Product Change Notification

1. ECN #: 249483

- USB-B-S-X-X-SM-X-XX

Before Change

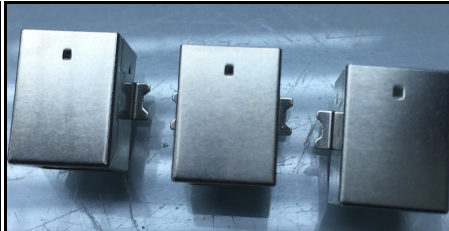
The plating process has been changed from a bright tin finish to Matte tin finish.

The surface finish will change from a glossy finish to a matte finish.

- Form - The part appearance will change from a glossy finish to a matte finish with no other fit or functional issues.
